EIA Coordinator's Statement regarding modifications to the Combined Cycle Gas Turbine and Liquefied Natural Gas Receiving, Storage, and Re-gasification Facilities at the Delimara Power Station as proposed by ElectroGas Malta Limited (EGM) following the submission in 2016 of the Addendum to the Environmental Impact Statement (EIS) regarding the aforementioned development.

# **IPPC Permit Renewal Variations**

This document provides an overview of the variations that shall be put forward for the upcoming renewal process of IPPC permit IP 0002/07/Gi – ElectroGas Malta Ltd

### **Update to the marine water quality study forming part of the environment impact statement for the proposed CCGT and LNG storage and regasification plant at the Delimara Power Station in view of IPPC permit renewal variations**

Figure 1 - Site plan showing current (A) and planned location (B) for make-up water glycol tank. Shaded area represents the main Regas bunded area.

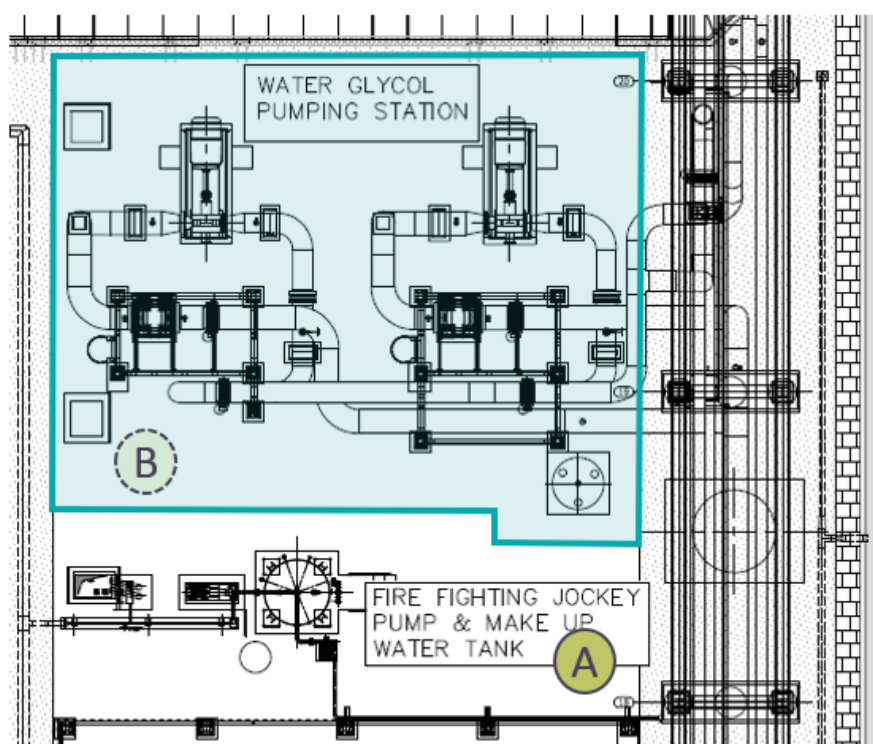
The current make-up water glycol tank was moved to the main bunded area within the Regasification plant, such that the present bunding of this tank is improved. This move will further reduce the risk of groundwater contamination.

Figure 6 – As-built plans of the Delimara 4 Portacabin Offices.

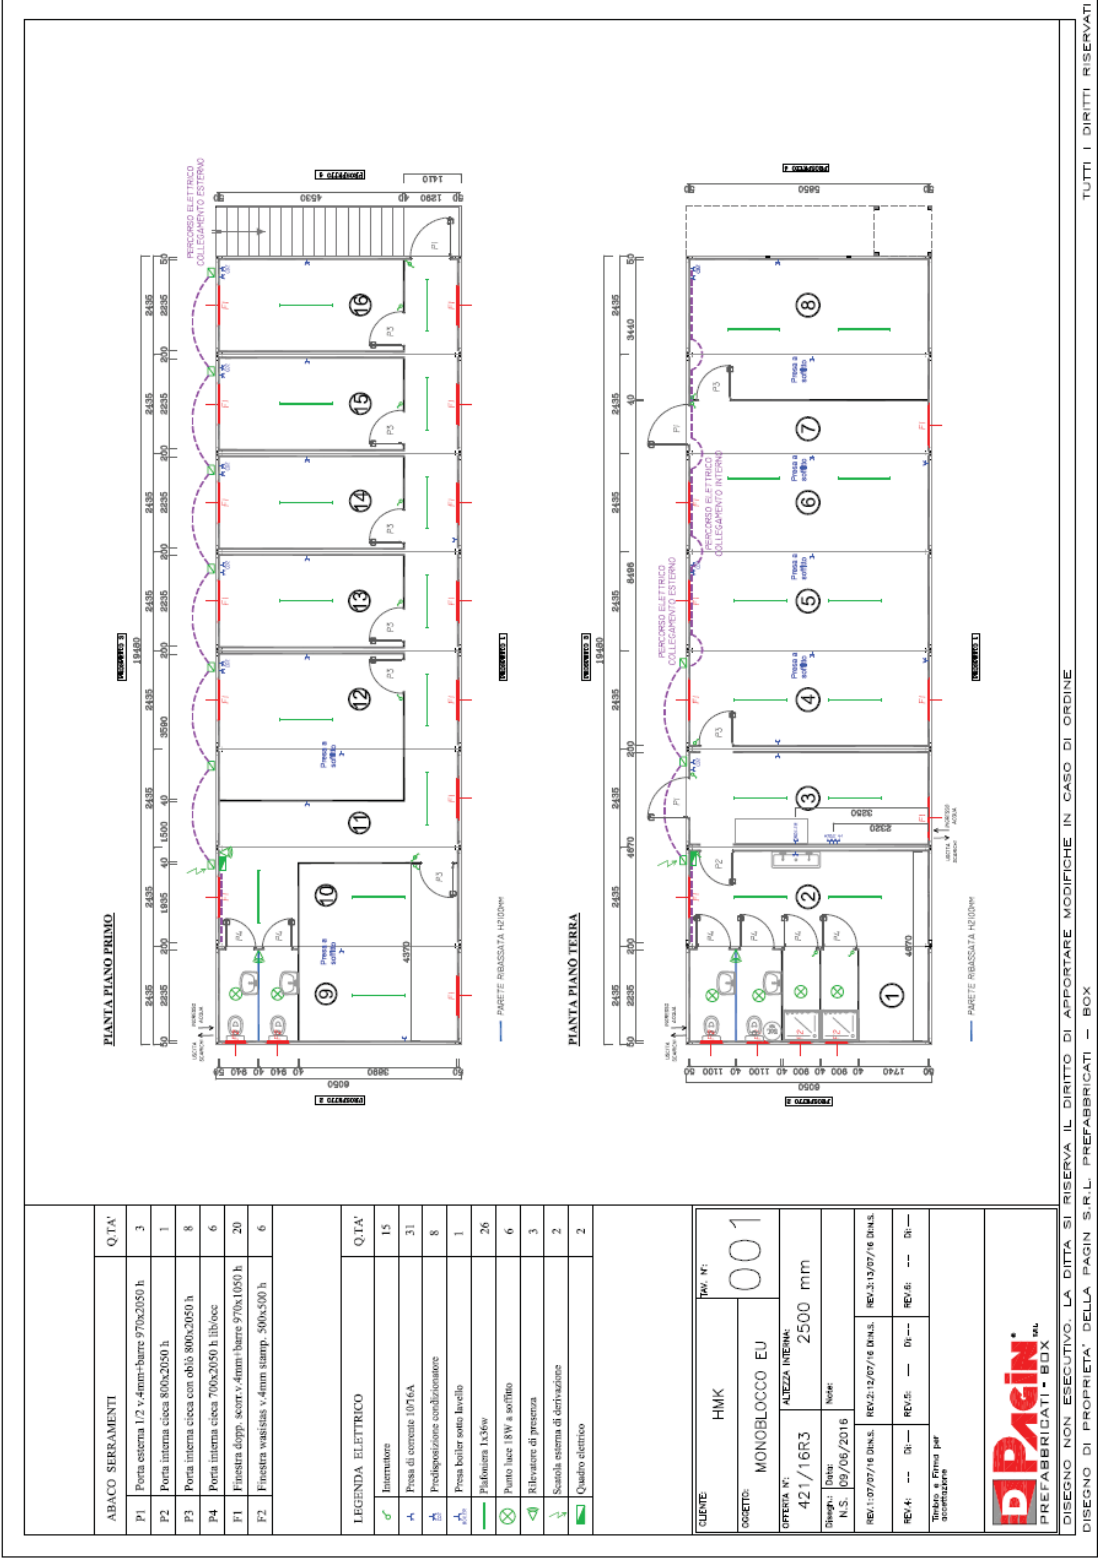
A total of sixteen 20-foot portacabins have been installed in Delimara 4 area to be used as offices. The portacabins have been placed such that a row of 8 units placed adjacent to each, are stacked on top of another row of 8 units. Layouts of the ground floor and the 1<sup>st</sup> floor are shown in Figure 6, whereas Figure 7, shows the location of these portacabins. Planning Authority's decision to grant permission for these offices (PA/04297/18) was posted on 17<sup>th</sup> November 2018, with commencement date being 10<sup>th</sup> December 2018.

Figure 7 - Site plan of Delimara 4 area showing the locations of the Portacabin Offices (yellow) and the Chemical Stores (red & orange).

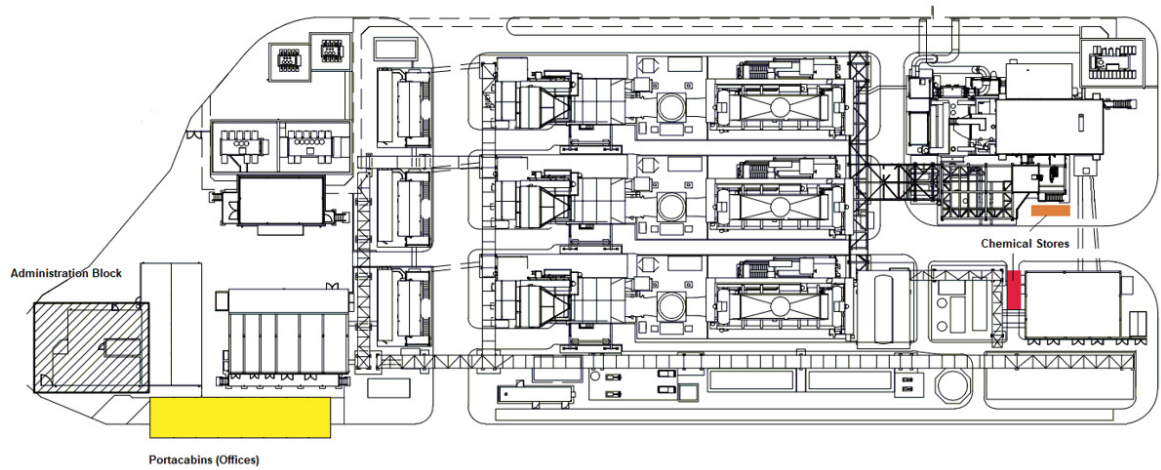
Two 20-foot containers were placed on site as shown in the site plan below, in order to be utilised as chemical stores within the Delimara 4 area.

Figure 9 - Layout showing the portacabin arrangement of Reganosa offices.

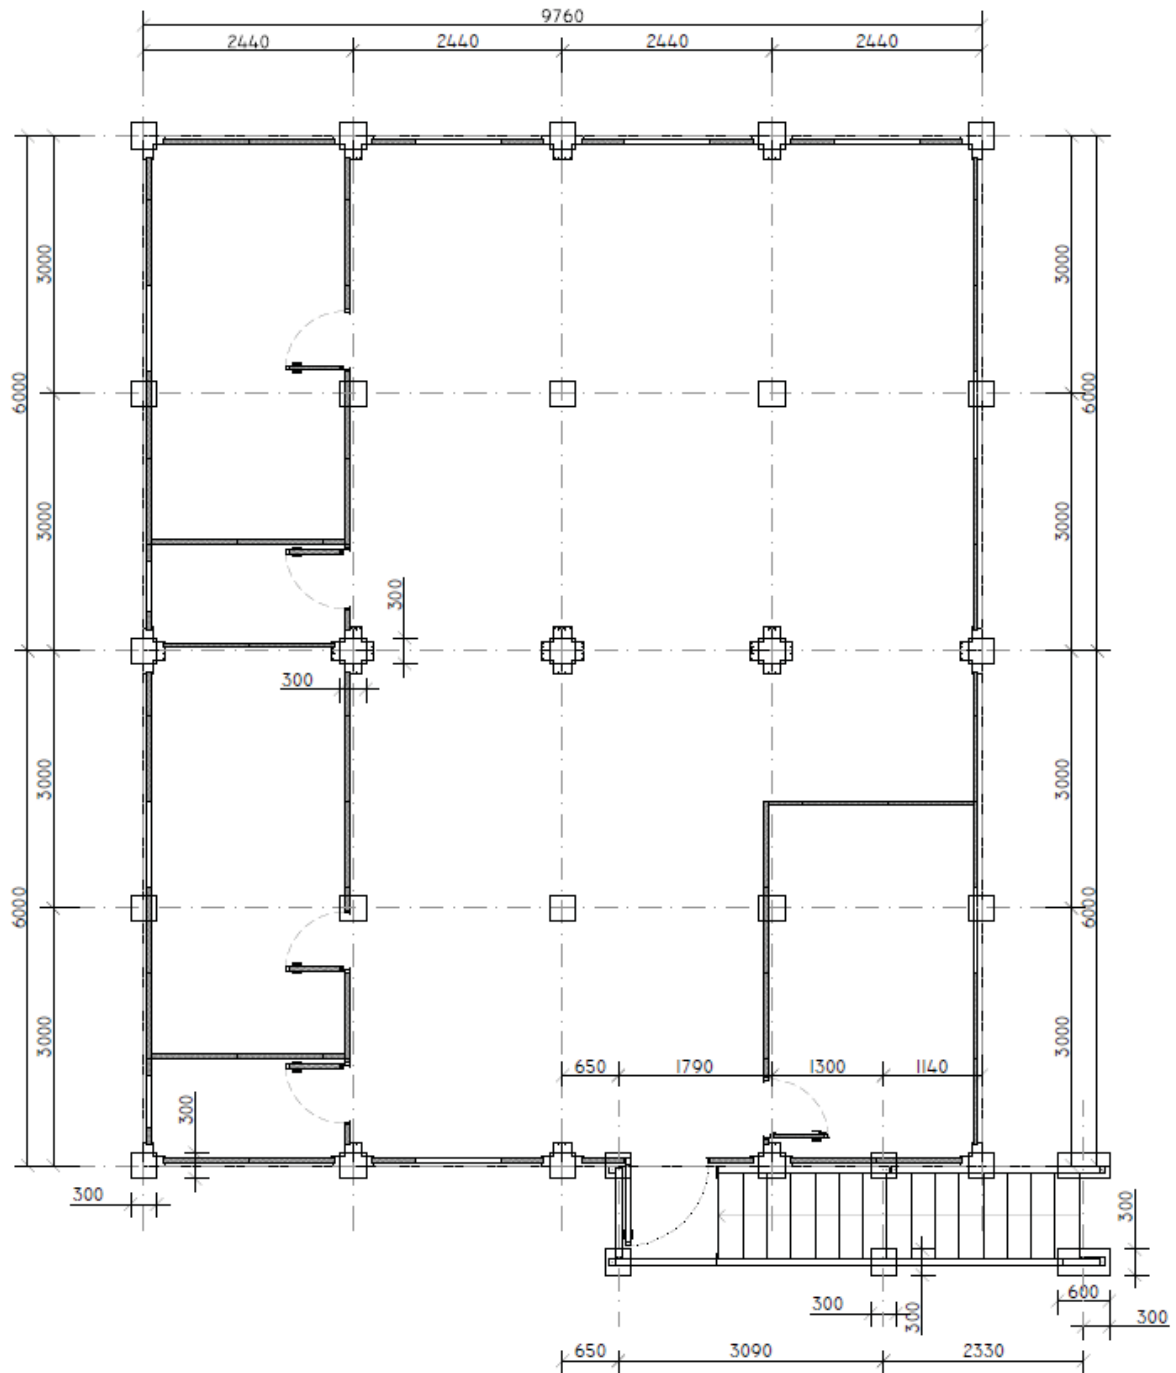
A new modular office building was installed in the Regasification area and is composed of 16 modules distributed over two floors, the arrangement of which is shown in Figure 9. The installation of cabins in the re-gasification area together with storage containers (PA/04118/18), was granted permission by the Planning Authority, with 12<sup>th</sup> November 2018 as the commencement date.

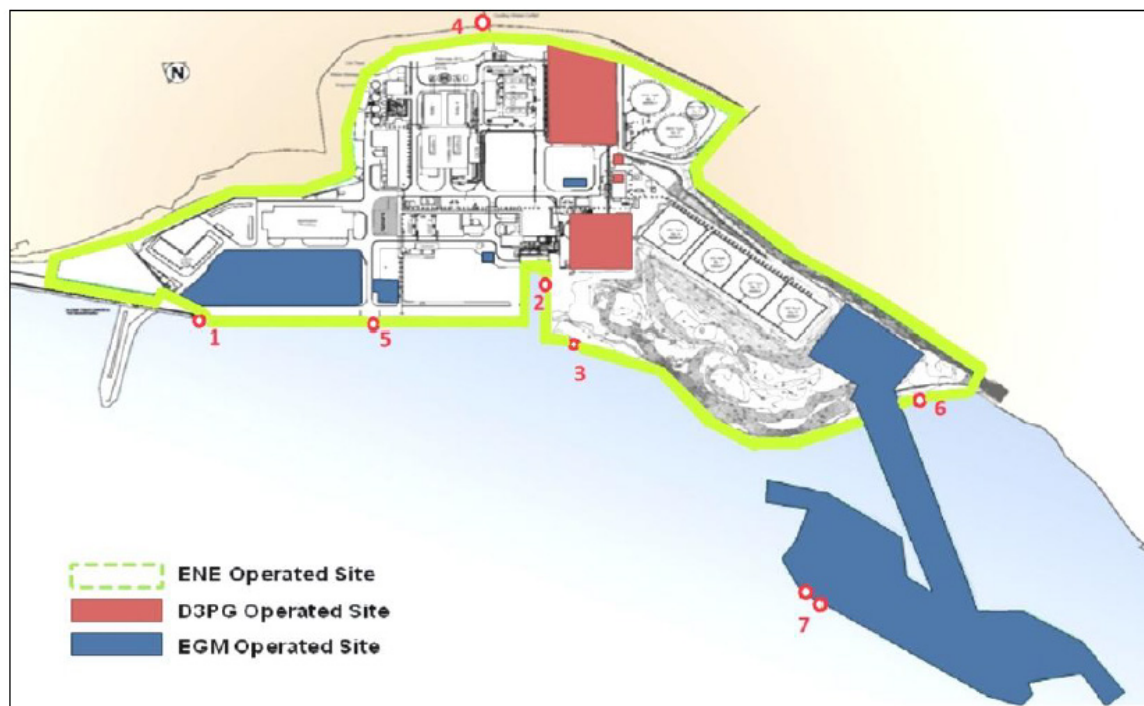
EGM describe this variation as representing installation of an above-ground oil water separator in the regasification area, the purpose of which is to receive wastewater generated from the operational activities of air compressors. The effluent is monitored and if compliant it is discharged at Discharge Point 1<sup>6</sup>; see Figure 1.

EGM have installed a new main cooling sea water pump that is identical to the one already in use and which is included in the existing IPPC permit. The new pump was installed following freeing up of physical space in the area as a result of D1 decommissioning, and is aimed at increasing reliability of the steam turbine through redundancy to improve security of supply. Only one of the pumps is operational at any given time; hence installation of the second pump provides backup and ensures continuity of operations, should there be issues with either of the two pumps. Installation of the second pump does not result in any changes to the volume and physico-chemical characteristics of the thermal effluent released at Discharge Point 4 (see Figure 1).

EGM installed a cooling water mixing chamber to allow connection of the D4 seawater piping to the main outfall using the D1 seawater pipes. In the meantime, the D1 plant has been fully decommissioned, such that the mixing chamber is now for the sole use of D4. Overall, such modification will not result in any changes to the volume and physico-chemical characteristics of the thermal effluent released at Discharge Point 4 (see Figure 1).
